# UNITED STATES PATENT AND TRADEMARK OFFICE

APPLICATION NO.	FILING DATE	FIRST NAMED INVENTOR	ATTORNEY DOCKET NO.	CONFIRMATION NO.
10/698,266	10/31/2003	Leo Wenstrup	1-16404	1672
7590 05/08/2006 Marshall & Melhorn, LLC Attn: Mark A. Hixon, Esq. 8th Floor Four SeaGate Toledo, OH 43604			EXAMINER LUONG, VINH	
			ART UNIT 3682	PAPER NUMBER
DATE MAILED: 05/08/2006

<b>Office Action Summary</b>	<b>Application No.</b> 10/698,266	<b>Applicant(s)</b> WENSTRUP ET AL.	
	<b>Examiner</b> Vinh T. Luong	<b>Art Unit</b> 3682

Fig. 3

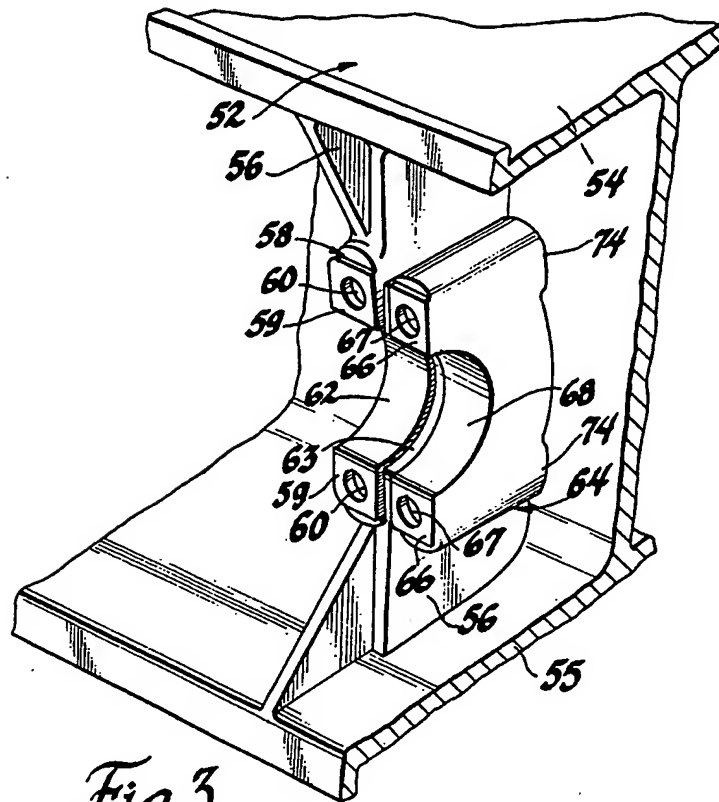
Regarding claim 3, each end (at 60 in Fig. 3) of said pilot web 56 comprises two apertures 60, and said differential carrier (not shown in Fig. 3) comprises four apertures in complementary positions to said apertures 60 of said pilot web 56. *Ibid.* col. 2, line 47 through col. 3, line 58, and claims 1-3.

Regarding claim 4, the pilot web and differential carrier assembly of the embodiment of Fig. 3 comprises four bolts disposed through said complementary apertures 60 and 67 of said pilot web 56 and said differential carrier 64. *Ibid.* col. 2, line 47 through col. 3, line 58, and claims 1-3.

Regarding claim 5, the pilot web and differential carrier assembly of the embodiment of Fig. 3 comprises four bushings 71, each of said bushings 71 being disposed about a corresponding one of said bolts 70. *Ibid.* col. 2, line 47 through col. 3, line 58, and claims 1-3.

Regarding claim 3, each end (at 60 in Fig. 3) of Arnold's pilot web 56 comprises two apertures 60, and Arnold's differential carrier or the like (not shown in Fig. 3) comprises four apertures in complementary positions to said apertures 60 of said pilot web 56. *Ibid.* col. 2, line 47 through col. 3, line 58, and claims 1-3.

Regarding claim 4, the pilot web and differential carrier assembly of the embodiment of Fig. 3 of Arnold comprises four bolts disposed through said complementary apertures 60 and 67

Regarding claim 5, the pilot web and differential carrier assembly of the embodiment of Fig. 3 of Arnold comprises four bushings 71, each of said bushings 71 is disposed about a corresponding one of said bolts 70. *Ibid.* col. 2, line 47 through col. 3, line 58, and claims 1-3.

Fig. 4

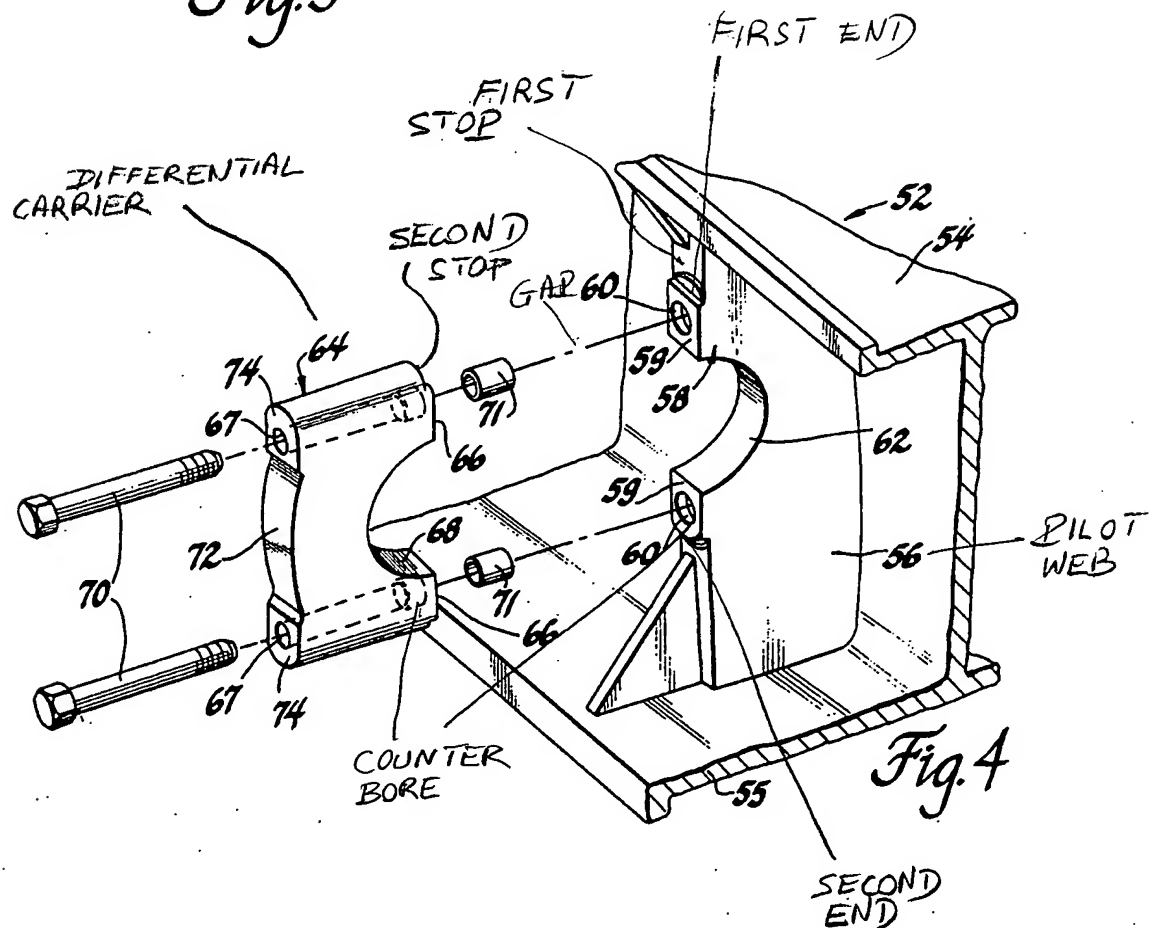
a first stop (Att., Fig. 4) on said pilot web 56;

a second stop (Att, Fig. 4) on said differential carrier 64, said second stop (Att.) being disposed adjacent to, and aligned with, said first stop (Att.), wherein said first and second stops (Att.) define a gap there between;

Regarding claim 2, each end (at 60 in Fig. 4) of said pilot web 56 comprises a single aperture 60, and said differential carrier 64 comprises two apertures 67 in complementary locations to said apertures 60 of said pilot web 56.

Regarding claim 6, the pilot web and differential carrier assembly of the embodiment of Fig. 4 comprises two bushings 71, one of said bushings 71 is disposed about a corresponding one of said bolts 70 at said first end (Att.) of said pilot web 56, and the other of said bushing 71 is disposed about a corresponding one of said bolts 70 at said second end (Att.) of said pilot web 56. See col. 4, line 61 through col. 5, line 3.

Regarding claim 7, each of said apertures 60 in said pilot web 56 and each of said apertures 67 in said differential carrier 64 which correspond to one of said bushings 71 is counter bored (Att., Fig. 4) to receive the bushing 71. *Ibid.* col. 2, line 47 through col. 3, line 6.

Regarding claim 10, the gap between said first stop (Att., Fig. 4) and said second stop (Att.) is inherently selected to essentially maximize transfer of forces from the pilot web 56 to the carrier 64. Note that a “whereby” or “wherein” clause that merely states the inherent result of the limitations set forth in the claim adds nothing to the patentability or substance of the claim. *Texas Instrument Inc. v. International Trade Commission*, 26 USPQ2d 1018 (Fed. Cir. 1993); *Griffin v. Bertina*, 62 USPQ2d 1431 (Fed. Cir. 2002); *Amazon.com Inc. v. Barnesandnoble.com Inc.*, 57 USPQ2d 1747 (Fed. Cir. 2001).

Regarding claim 2, each end (at 60 in Fig. 4) of Arnold's pilot web 56 comprises a single aperture 60, and Arnold's differential carrier or the like 64 comprises two apertures 67 in complementary locations to said apertures 60 of said pilot web 56.

Regarding claim 6, the pilot web and differential carrier assembly of the embodiment of Fig. 4 of Arnold comprises two bushings 71, one of said bushings 71 is disposed about a corresponding one of said bolts 70 at said first end (Att.) of said pilot web 56, and the other of said bushing 71 is disposed about a corresponding one of said bolts 70 at said second end (Att.) of said pilot web 56. See col. 4, line 61 through col. 5, line 3.

Regarding claim 7, each of Arnold's apertures 60 in said pilot web 56 and each of Arnold's apertures 67 in said differential carrier or the like 64 which correspond to one of said bushings 71 is counter bored (Att., Fig. 4) to receive the bushing 71. *Ibid.* col. 2, line 47 through col. 3, line 6.
